Statement of persons granted permission to build.

— AMENDED —
— PLAN OF PROPOSED ADDITION —
— ON PLOT N^o 29B-D-3 —
— TEHILRAM QR —
— SCALE 8"=1" —

With reference to ^{his} _{their} application dated 13th December 1925 with aplan for the proposal ^{Building} _{additional} on plot No. 293 Survey Sheet No. 8-3

With reference to ^{his}~~their~~ application dated...4th November 25... with a plan for the proposed ^{Building}~~additional~~ on plot No. 29.B... Survey Sheet No. D3... Tahelraun... Quarter Mr. Kare Virchand... is informed that until the following requirements are complied with the plans cannot be passed.

— PLAN OF PROPOSED ADDITION —
— ON PLOT-N: 29B-D-3 —
— TEHILRAM Q: —
— SCALE 8-1 —

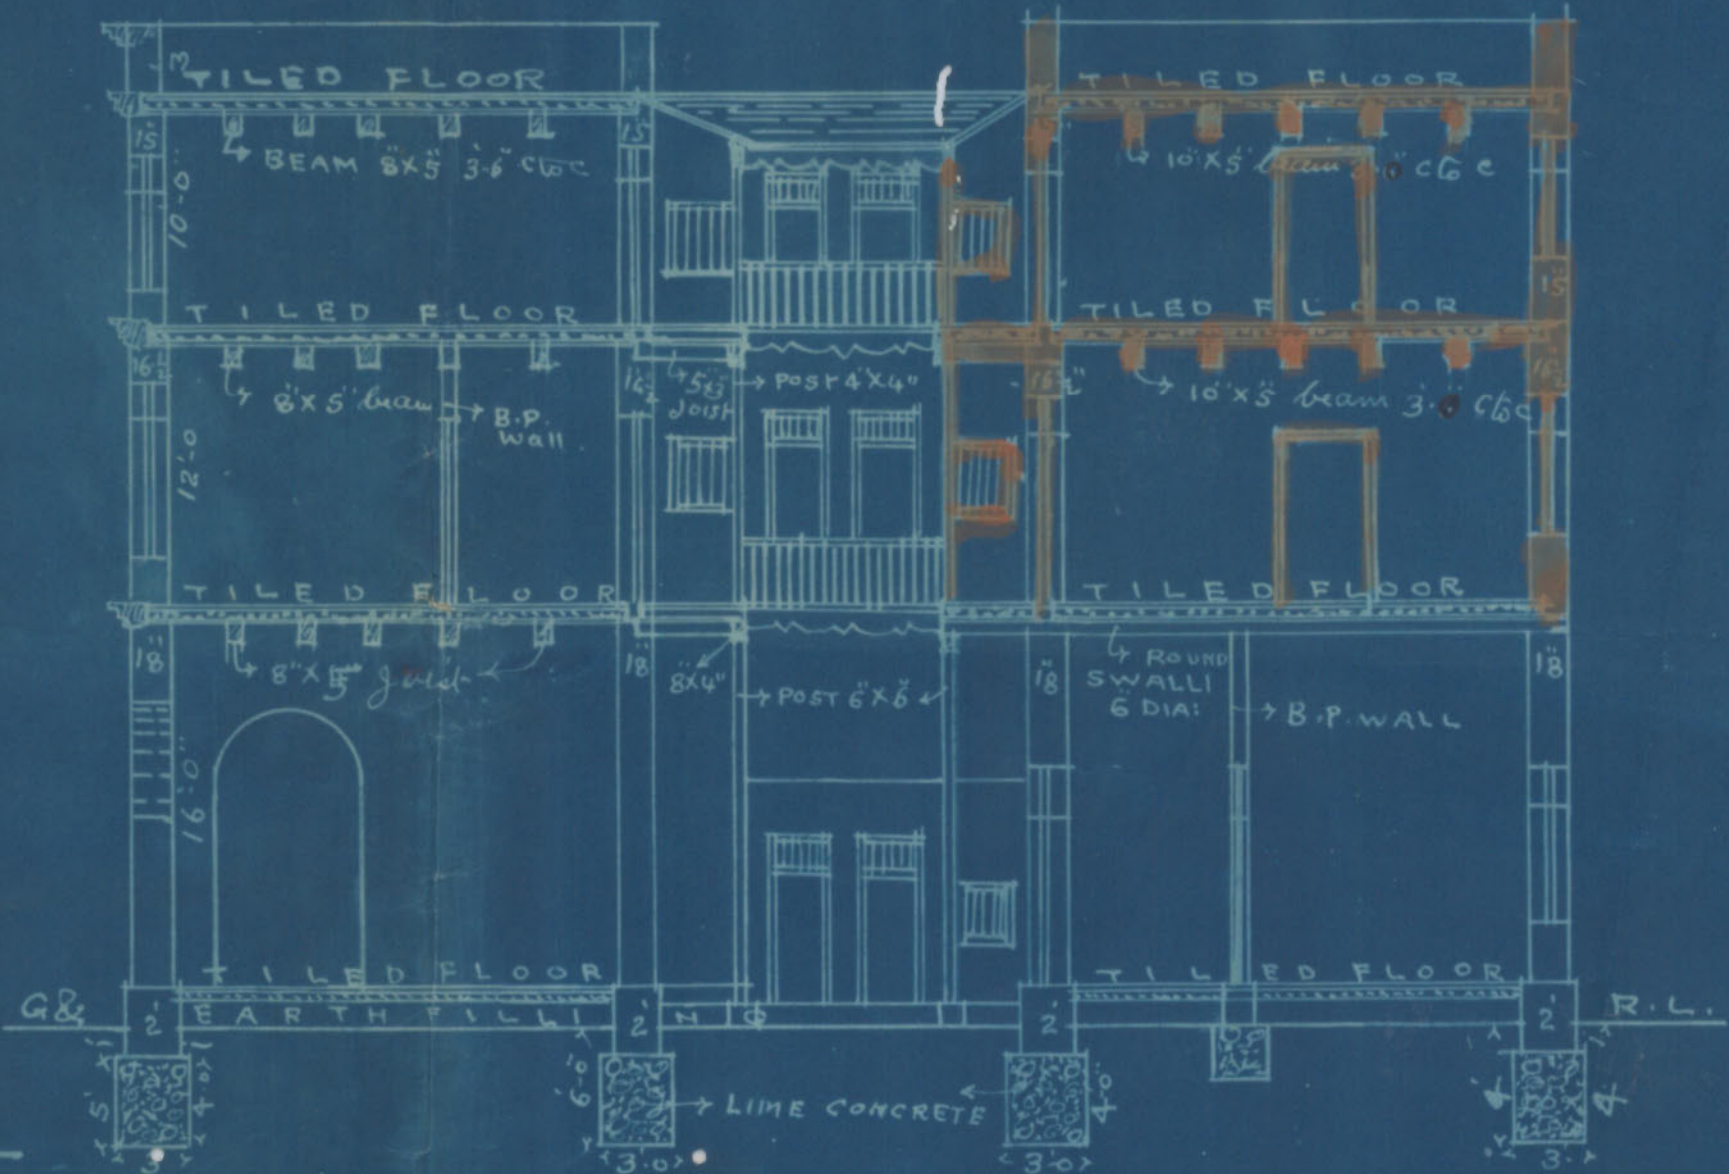
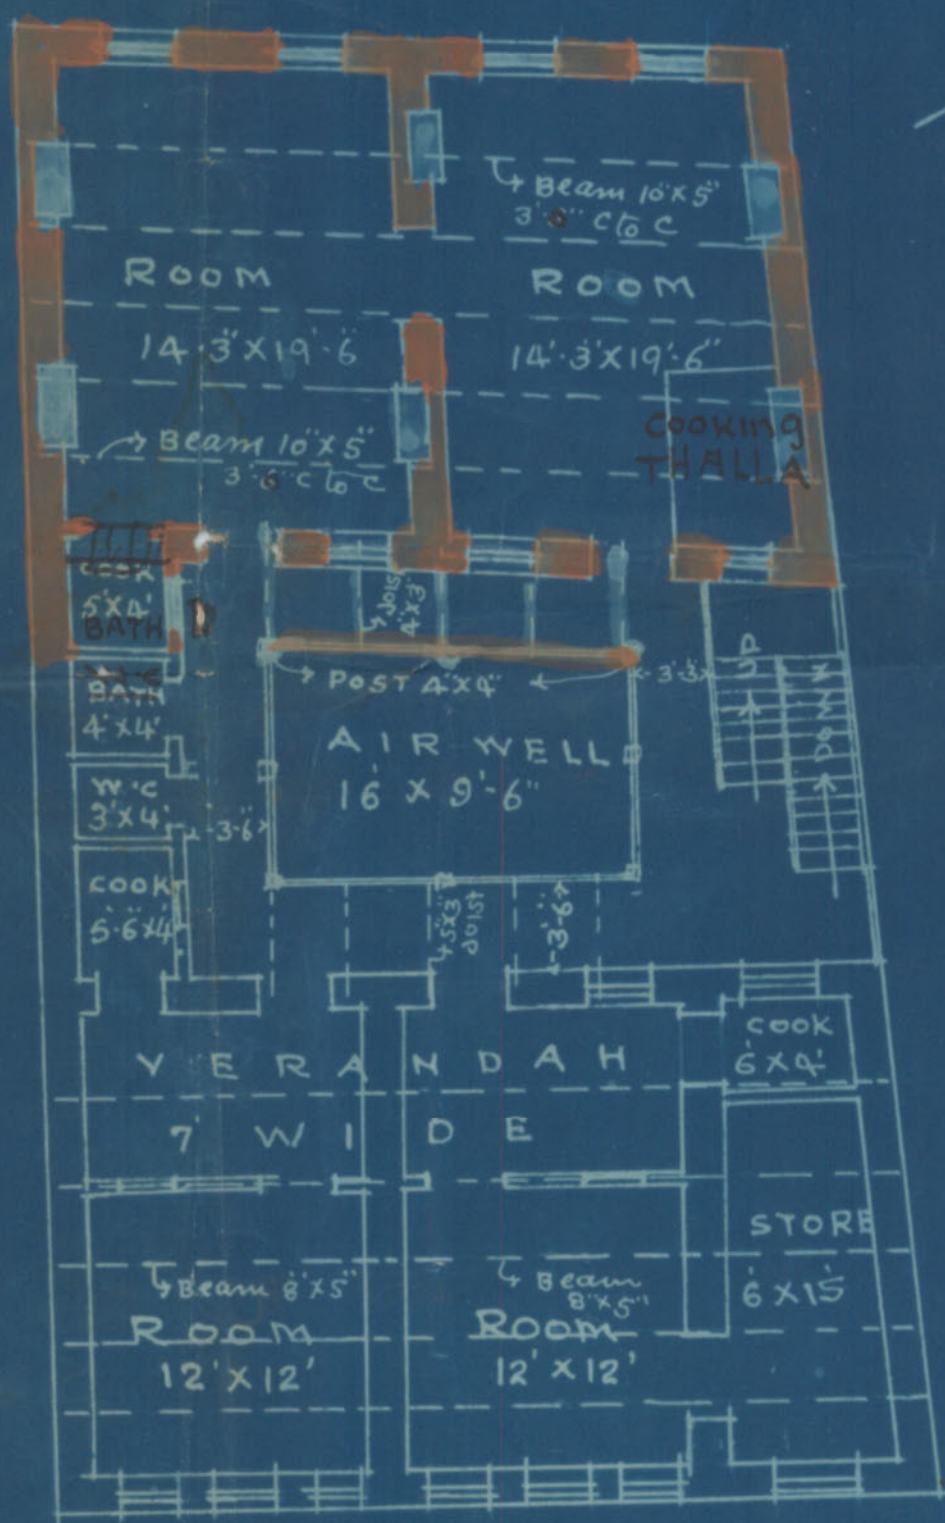
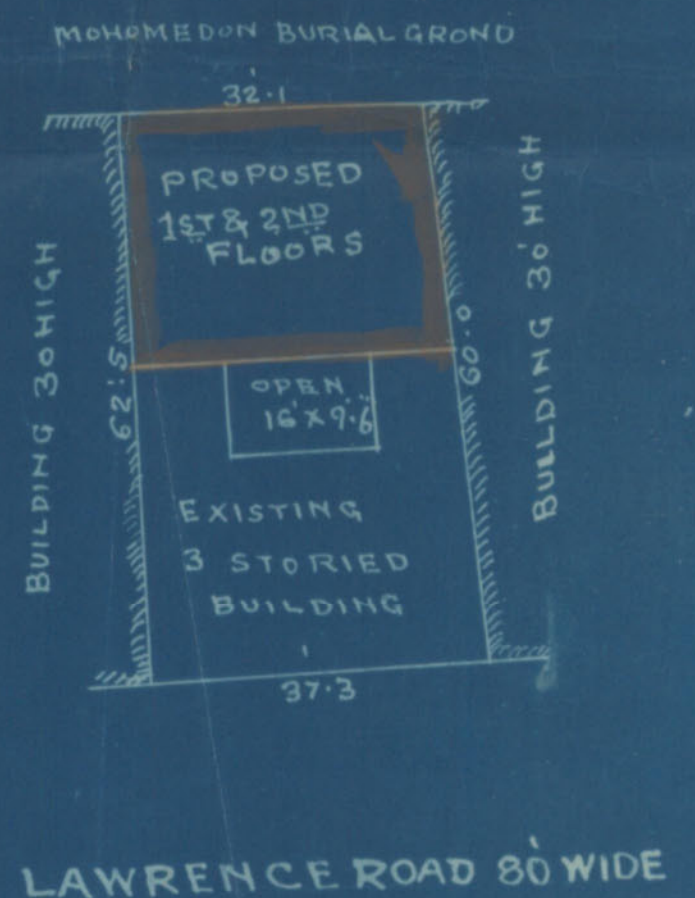
- (1) Open spaces provided is totally insufficient; in fact the additional floors will convert the
- (2) existing house into a
- (3) hindrance open on the burial ground for which permission is necessary from the owner.
- (4)
- (5)
- (6)
- (7)
- (8)
- (9)

Building Surveyor's Report wooden beams should be 3 ft. c to c and not 3.6 as mentioned. windows can not be allowed in the back towards land of other party unless they agree to this

Open space provided is
wholly insufficient, in fact
the additional flows will
convert the existing house
in boundary
Widows share the house
ground for which
provision is necessary
from the owner.
